**SUBJECT: Rice Solar Energy Project (RSEP), 09-AFC-10C
Limited Notice to Proceed with Modifications to Well 2**

Subject: Rice Solar Energy Project (RSEP), 09-AFC-10
Limited Notice to Proceed with Modifications to Well 2 (CTS Log # 2011-1438)

Subject: Rice Solar Energy Project (Docket No. 09-AFC-10C)
Well Modification Plan

Rice Well 2 Modification and Well Installation

AREA FOR RICE WELLS NO. 1 & 2

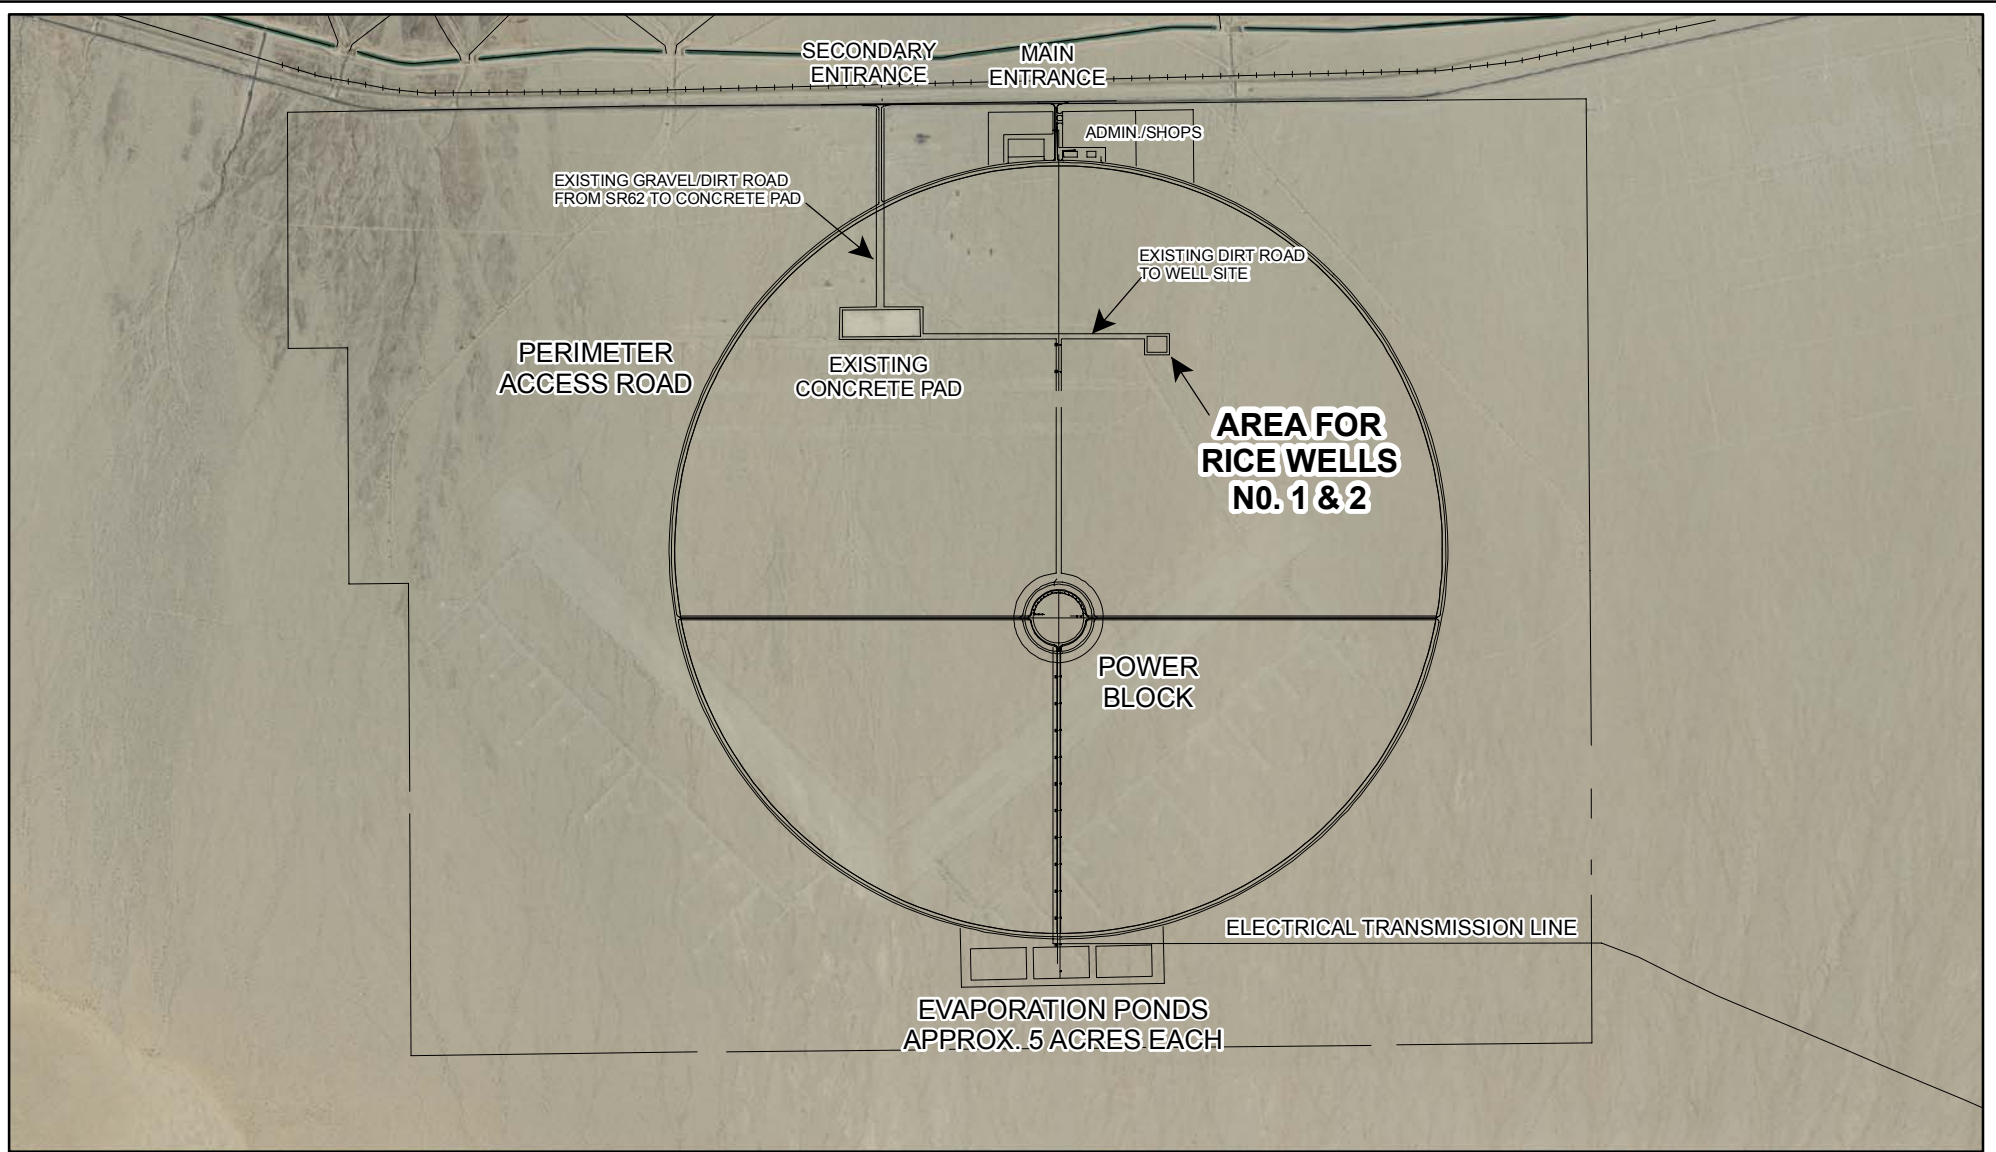
A concrete pad that exists near the Rice 2 Well Site will be accessed using an existing dirt and gravel road that extends from route 62. This pad will be used as a temporary staging area. The Rice Well 2 Site will be accessed via an existing dirt road that extends from the concrete pad, as indicated on Figure 1. There will be no need for vegetation clearing or road construction. Additionally, sand and silt areas along the access roads may be wetted down using a water truck to facilitate vehicle passage and suppress dust, if needed.

FIGURE 1
AREA FOR RICE WELLS NO. 1 AND 2
 RICE SOLAR ENERGY PROJECT
 RIVERSIDE COUNTY, CALIFORNIA

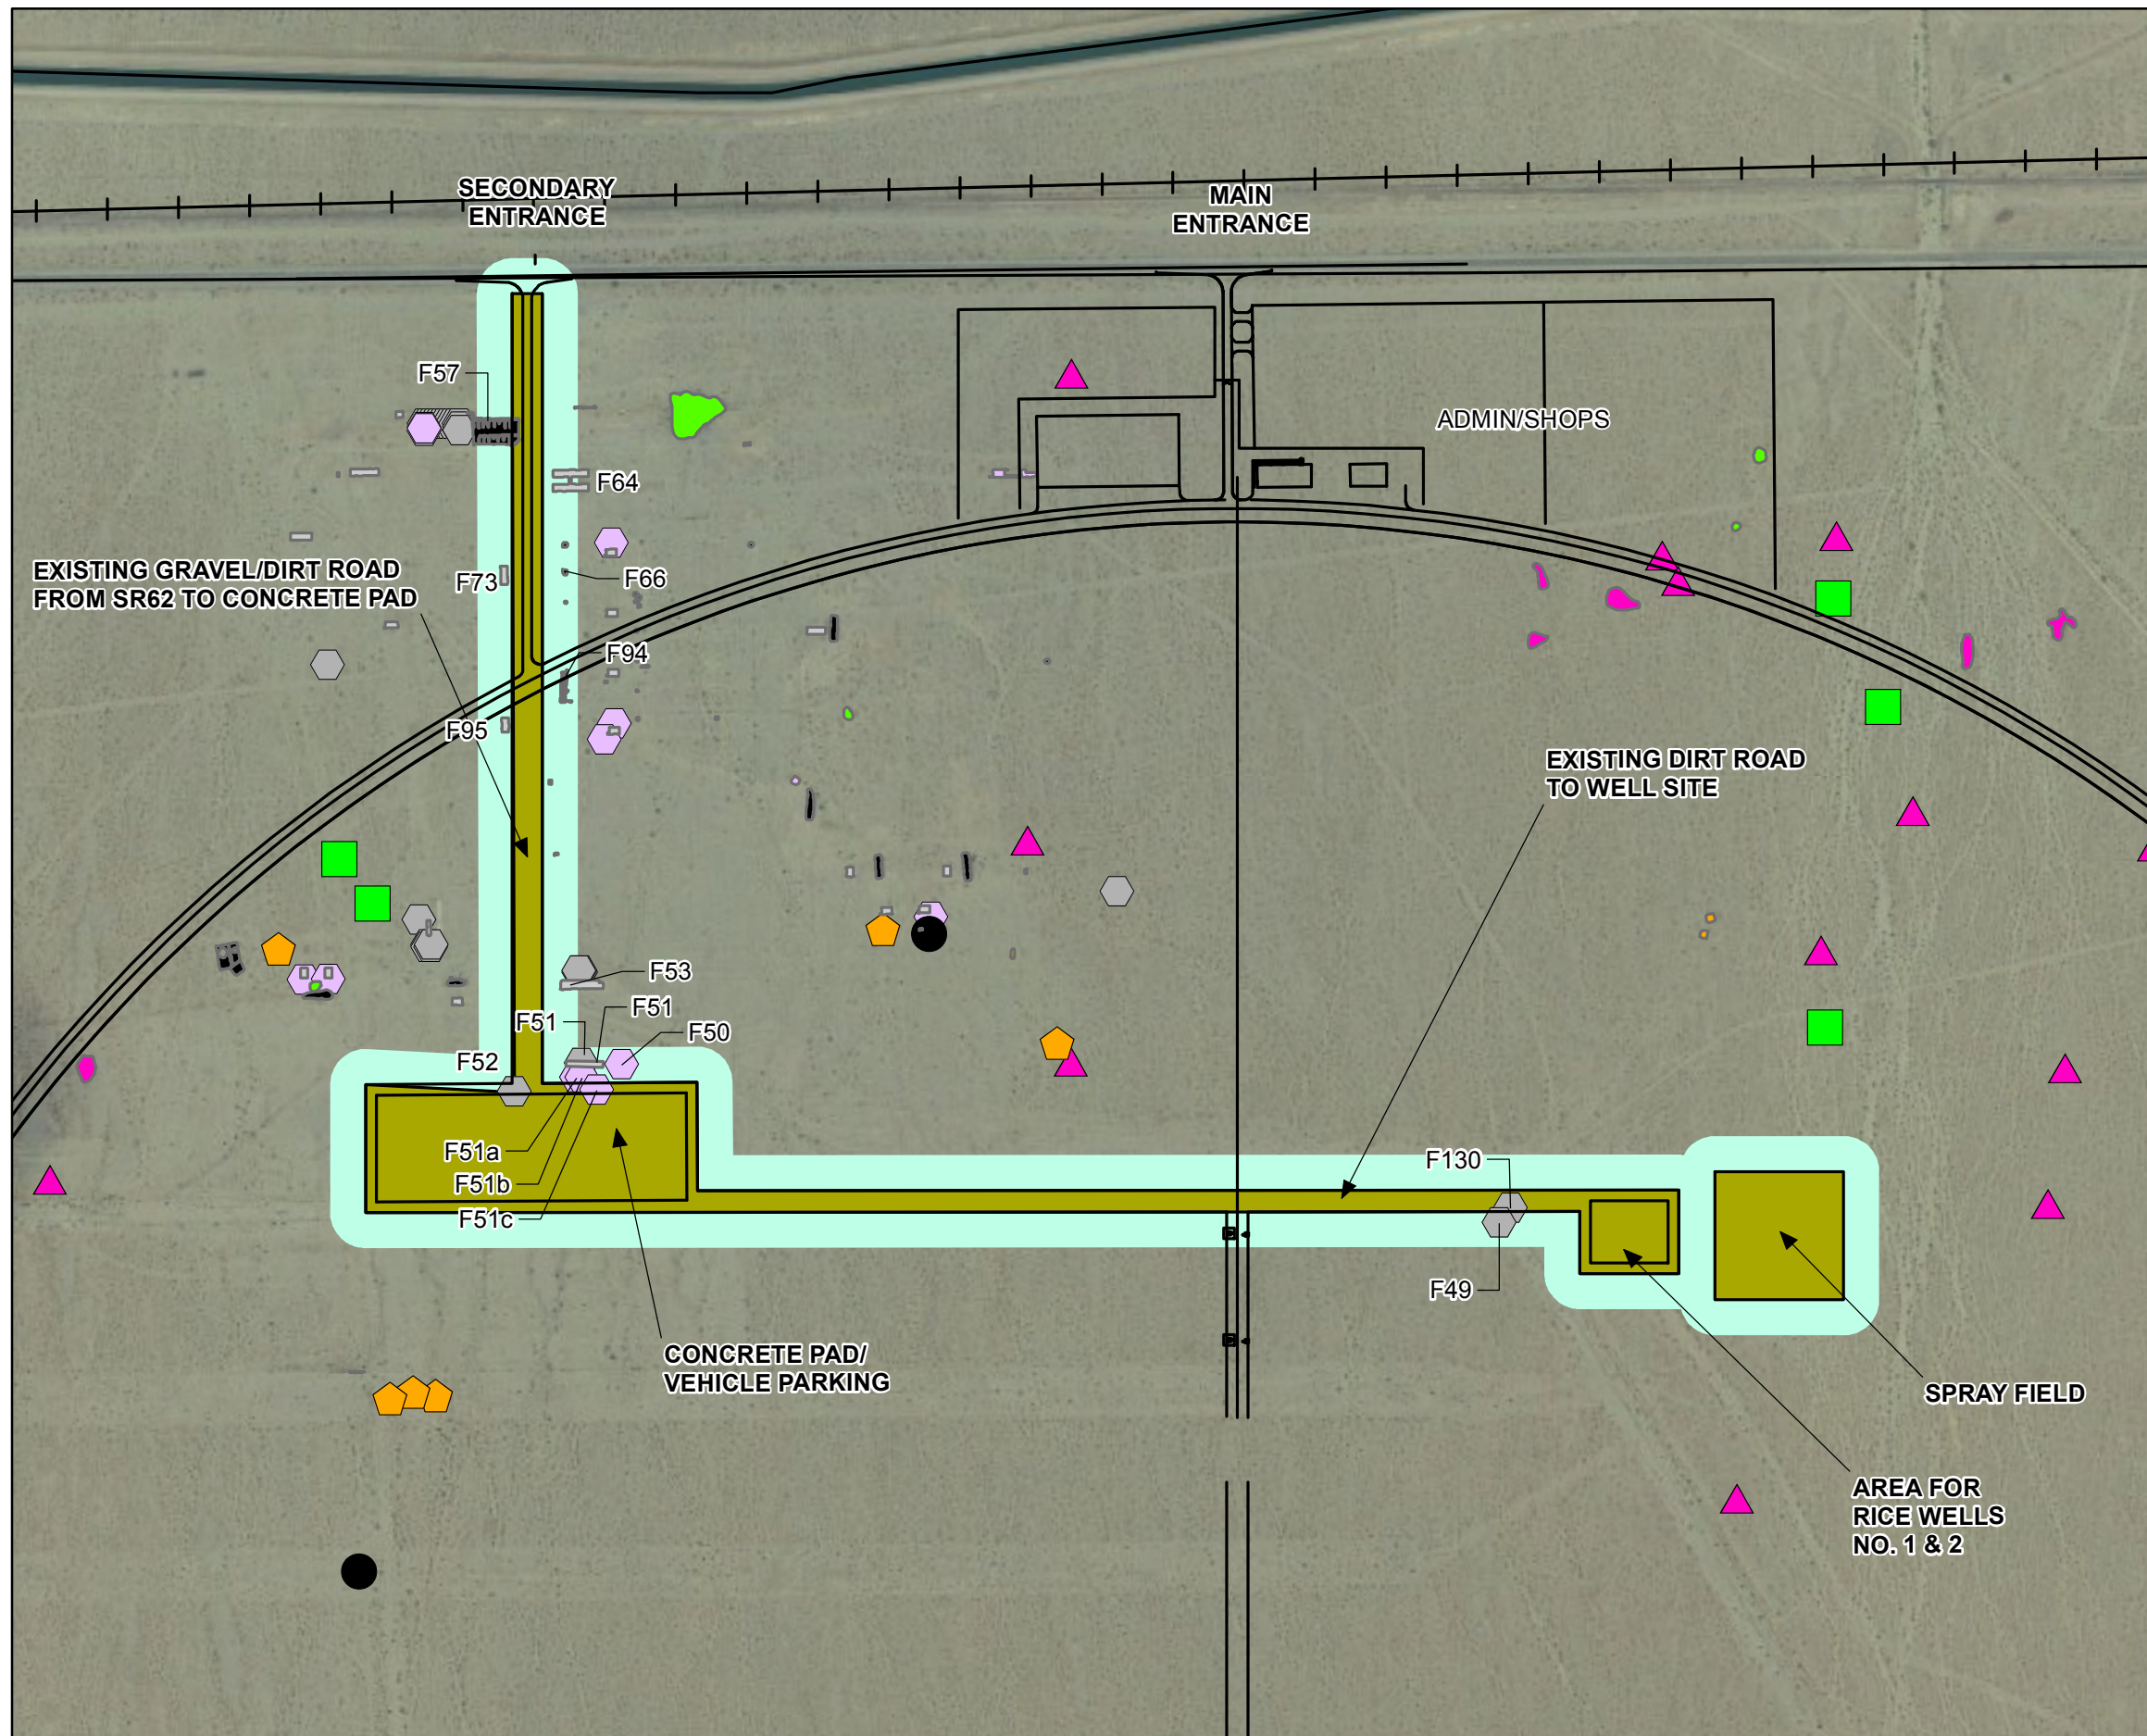
From the map it appears that the well modification work could impact, in the ways described below, the following historical RAA features:

- Feature 51a, Feature 51b, and Feature 51c, wood-lined pits located along the northern edge of Feature 52, between the access road and the northeast

corner of Feature 52, where staging, parking, and laydown activities could disturb them;

- Feature 52, a large concrete pad proposed for staging and laydown, where mechanical scraping by backhoes and similar machines used to move dirt piles and pipe and equipment could damage the pad; and
- Feature 130, a small concrete foundation located west of the Well 2 impact area directly on the east-west leg of the dirt access road, where heavy vehicle (e.g., drill rig) passage could crack and break it.

1. The project owner must avoid impacts to Feature 51a, Feature 51b, and Feature 51c by flagging a buffer area on the concrete pad (Feature 52) 30 feet around them and restricting staging, parking, and laydown activities from the buffer area;

2. The project owner must conduct data recovery on Feature 52 and Feature 130 per CUL-9, parts 4 and 5, and complete, per CUL-9, verification 2, a DPR 523c form, to be submitted for CPM review and approval;

3. The project owner is not required to provide archaeological monitoring of the well modification activities after the above avoidance and data recovery are completed; and

4. The project owner must inform the CPM of any changes in the described Well 2 modification activities and get CPM approval for these changes if they entail potential disturbance to cultural resources located outside the above specified impact areas, as depicted on the July 14 map provided to the CPM by the project owner.

The June 30 description you provided of the well modification activities includes the plan to use "a truck turnaround and laydown area of 50 by 100 feet" (p. 2).

This area is not depicted on the map provided today, or is not labeled as such. Please call me (916 654 4840) as soon as possible and identify on the map where this area is located.

I just spoke with Worley Parsons. The truck turn around/laydown area - which will really be used more for just turn around as any laydown would be on the large existing concrete pad where parking would be - so truck turnaround area is identified as "area for Rice wells No. 1 & 2". Apologies for not showing that on the map earlier.

Here you go. "To reiterate all activity will be contained within previously disturbed areas as depicted on the map. No new disturbance will occur. Existing concrete pad will be used for vehicle parking. "
